Architect's Supplemental Instructions

PROJECT: *(name and address)*
17-13 OSU College of Med. at Hastings
Tahlequah, OK

ASI INFORMATION:
ASI Number: Bid Package 03 - ASI 02
Date: 05-24-2019

Bid Package 03- ASI 02 – OSU College of Osteopathic Medicine At The Cherokee Nation

B3 ENLARGED STAIR PLAN - FIRST FLOOR FRAMING
SCALE: 1/4" = 1'-0"

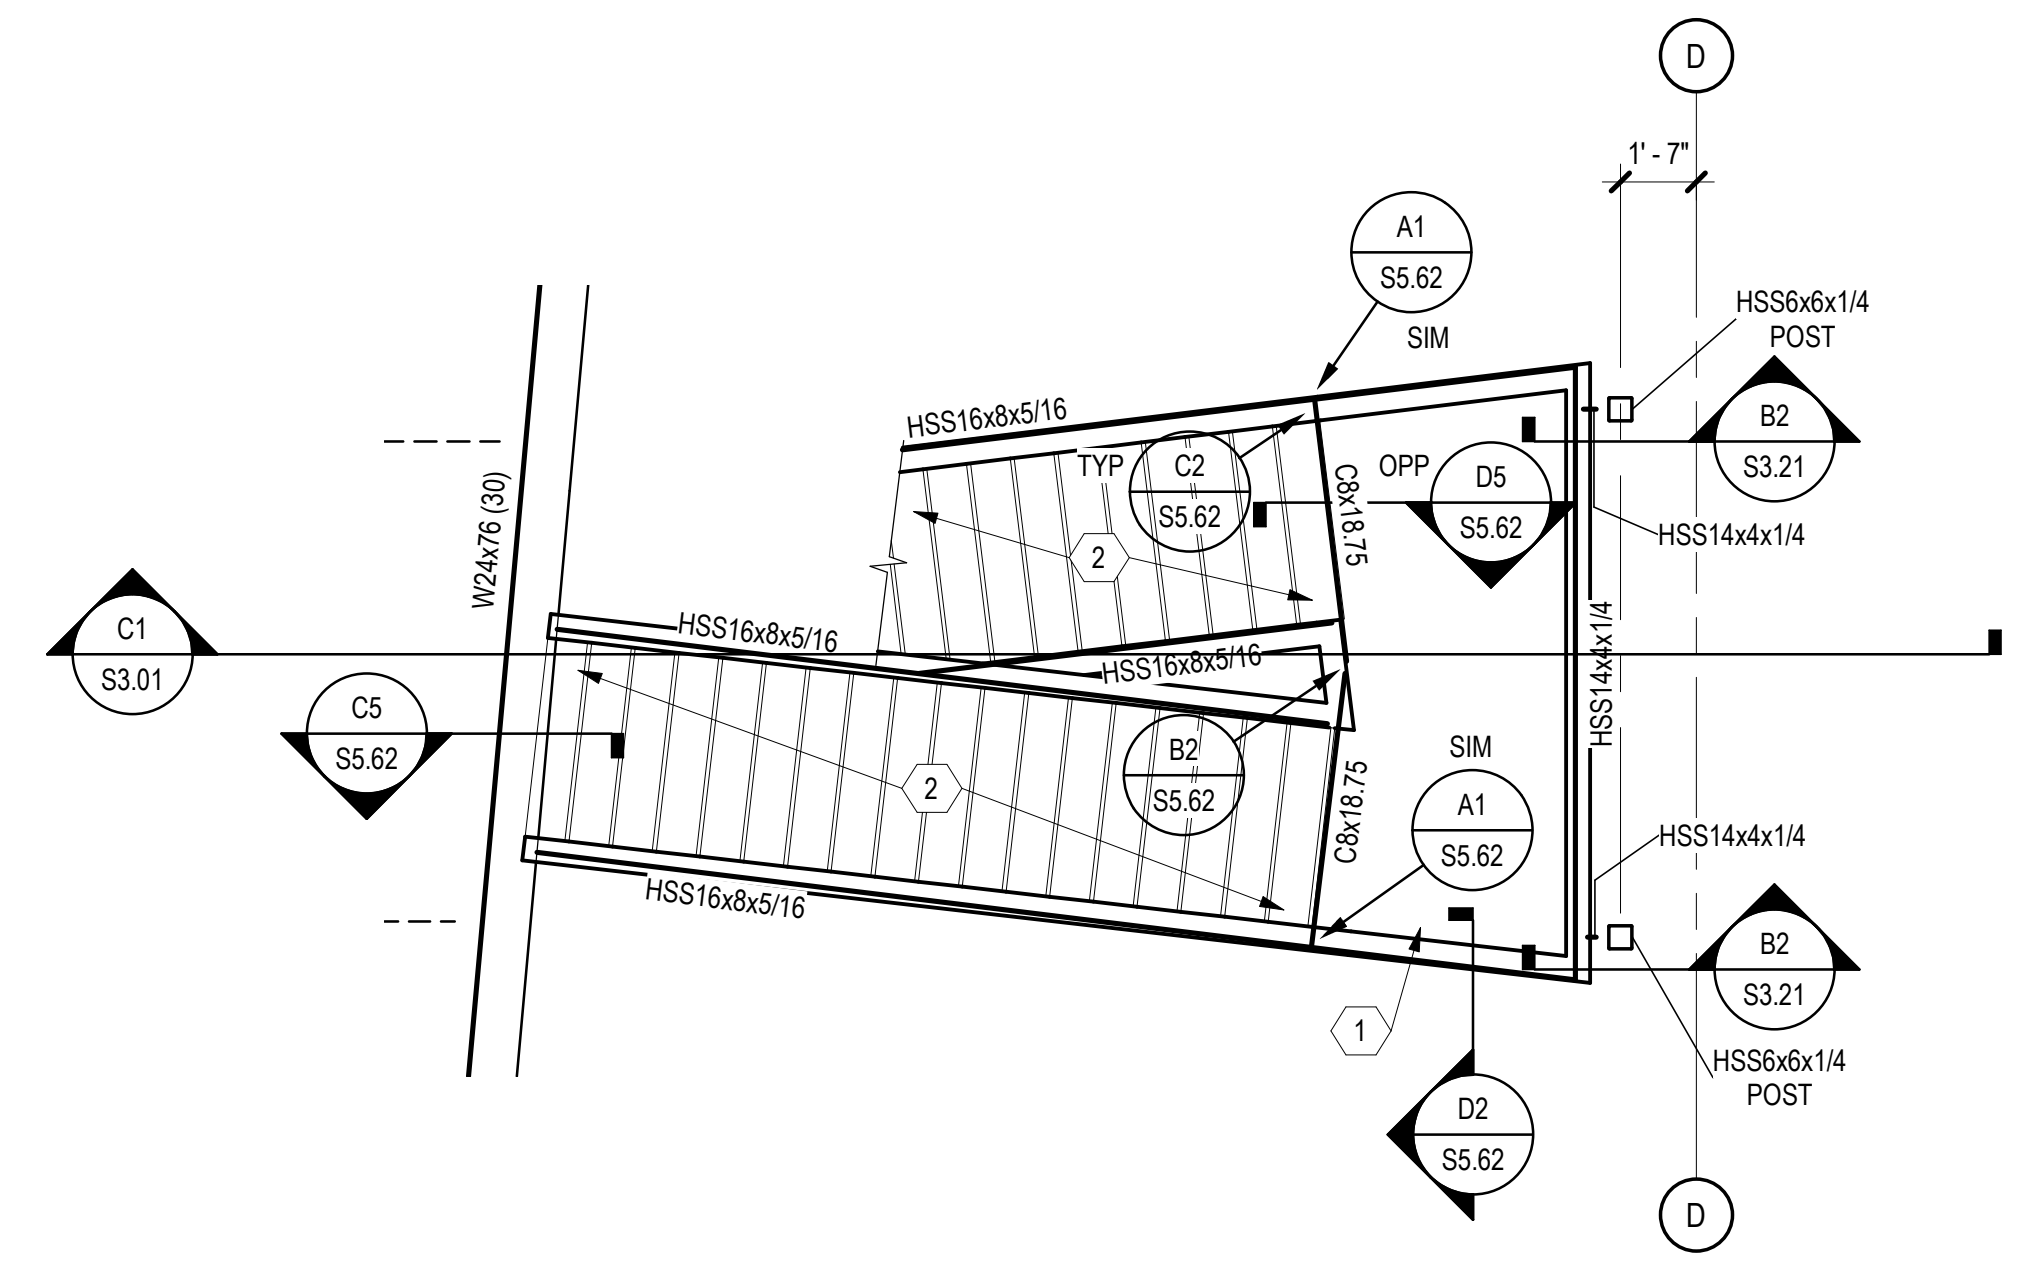
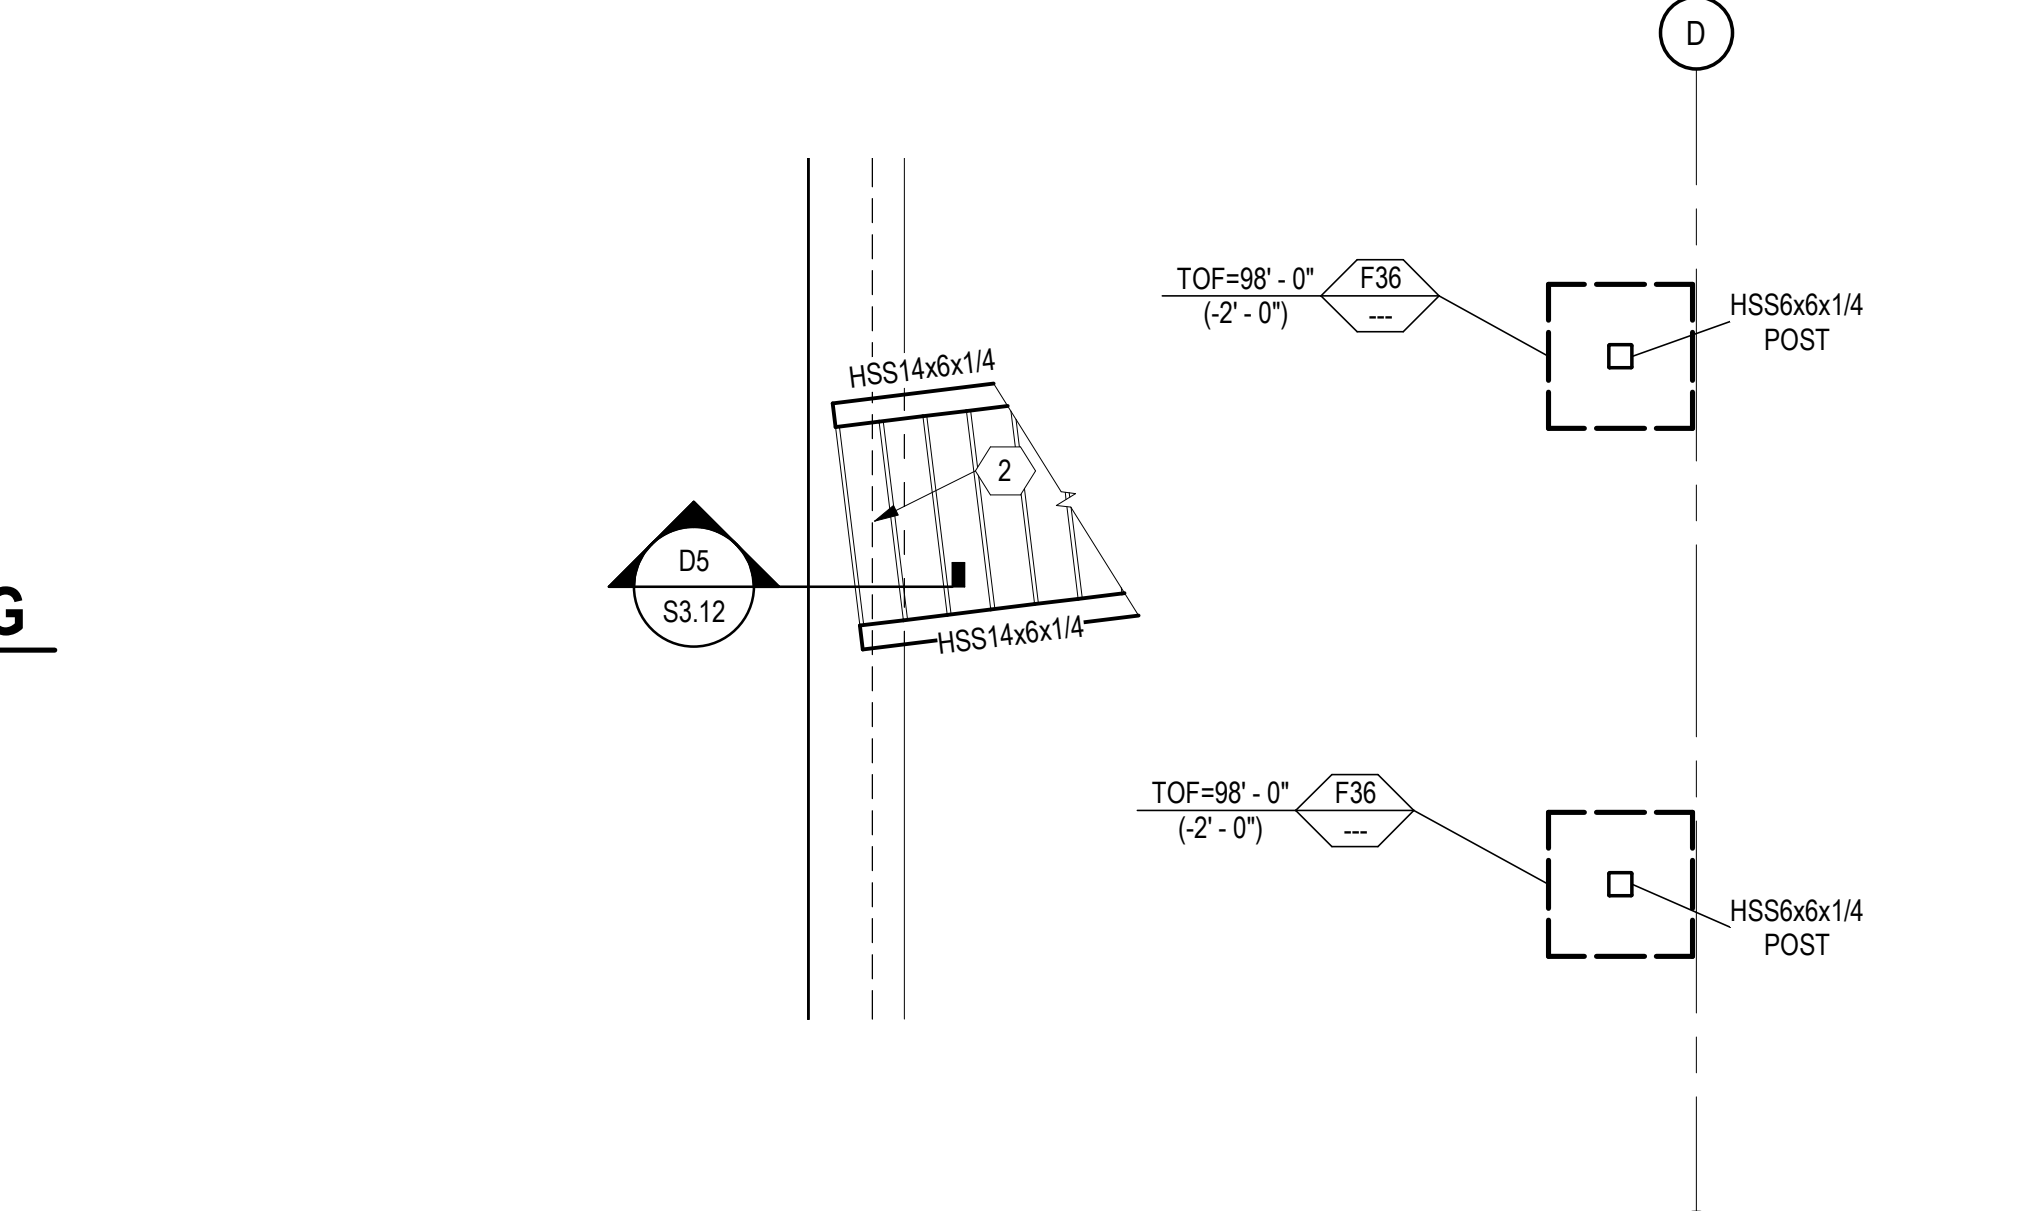
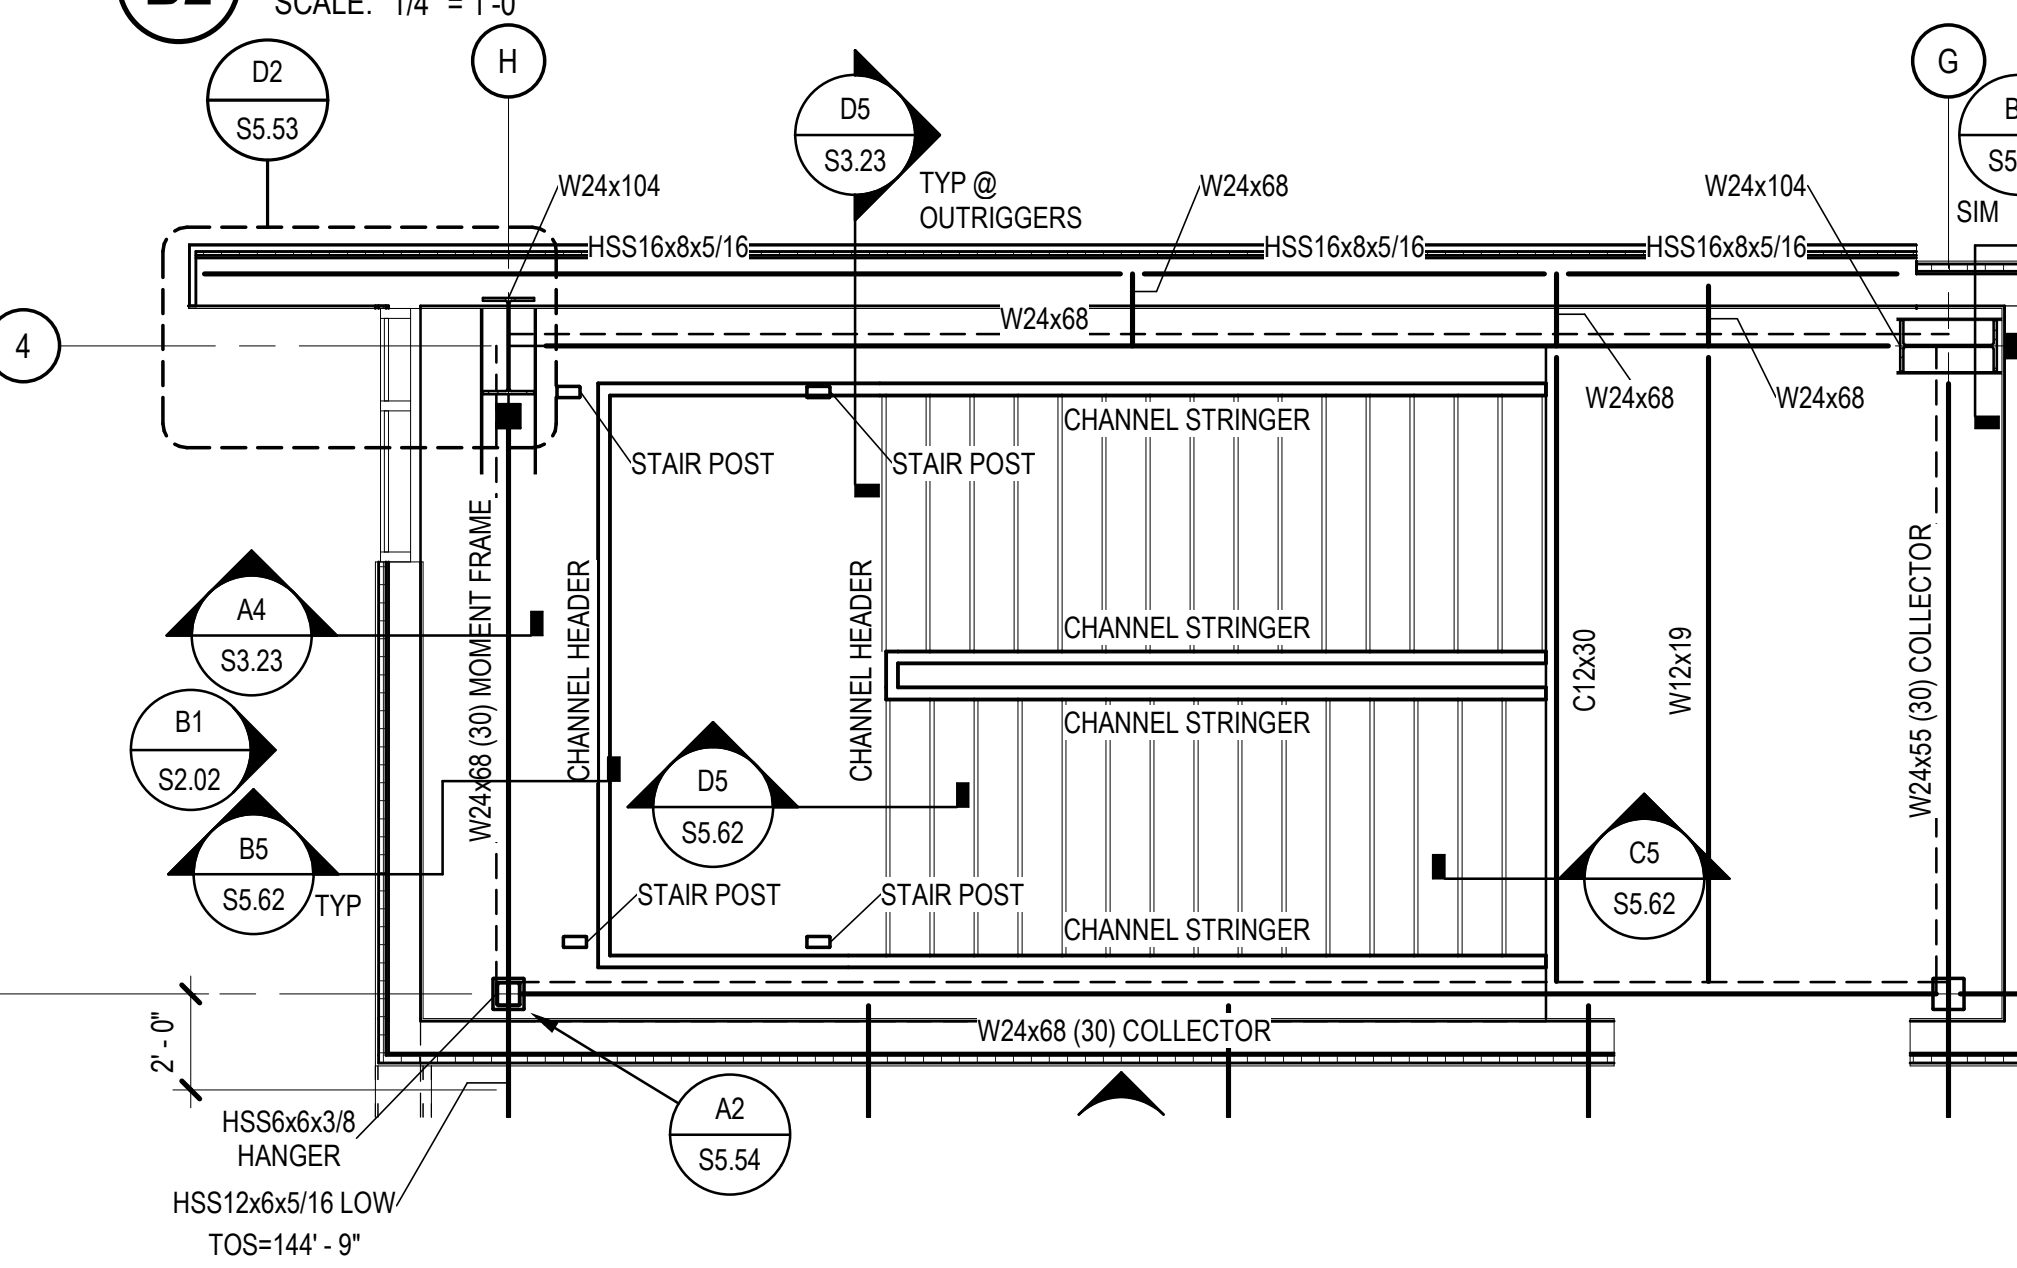
S3.11	Clarifying 'SIM' note added to section D3.
S3.11	Section B5 modified to accommodate raised glazing system.
S3.12	Section B2 added to accommodate raised glazing system.
S3.12	Section B3 modified to include additional beam sizes.
S3.12	Section A1 added to accommodate column furr outs.
S4.01	Entire sheet revised.
S4.02	Entire sheet revised.
S5.11	Clarifying 'SIM' note added to detail C1.
S6.01	Slab-on-grade schedule revised.
S6.01	Additional wall height added to schedule A1.

ENTIRE SHEET REVISED
